**Historical Architectural Review Board
COA Final Review Sheet**

HDC-2023-00012

Address: 325 N. 9th Street

Proposal: Replace garage doors

Image of proposed garage door.
(Applicant)

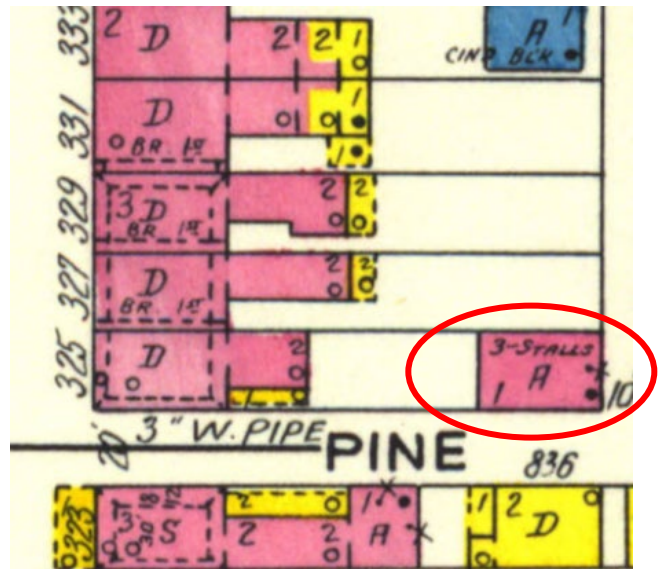
The installation of overhead garage doors will require the removal of the existing jambs, though the doors have simple jambs with no thresholds or transoms. Staff recommends adding glazing in the top third or half of the doors to maintain the solid-to-void ratio and comply with Guideline 3.6.6. Staff contends that alternative materials are acceptable at an accessory structure and asks that the applicant consider a more appropriate composite door system with vertical panels and glazing to comply with Guideline 3.6.9. However, staff recommends that the HARB take the previously approved paneled metal door into consideration.

Mr. Jordan opined that the scale, massing, and structure were more important than whether the doors contained glazing. Mr. Lichtenwalner contended that it would be difficult to match the proportions of the glazing in the garage door and that the windows would not pay respect to the historic value of the existing doors. He then questioned whether the door would maintain similar proportions to the example shown, noting that the sample shows a much wider door. He asked whether the smaller opening would significantly change the design. Mr. Sibri responded that the door company explained that the door would be custom made to fit the opening.

Denial of the application as presented, but approval of a vertically paneled metal or composite door with glazing, with the staff to review details, pursuant to Chapter 3, Section 3.6 Doors.

Mr. Encelewski moved to approve with conditions the application presented on 3/6/2023 for the installation of three garage doors at 325 N. 9th Street, as agreed to by the applicant and with the staff to review details, pursuant to Chapter 3, Section 3.6 Doors, provided the garage door openings are preserved and that the doors are cut symmetrically in design, noting that the brick piers present a unique circumstance. Mr. Hart seconded the motion, which carried with unanimous support.
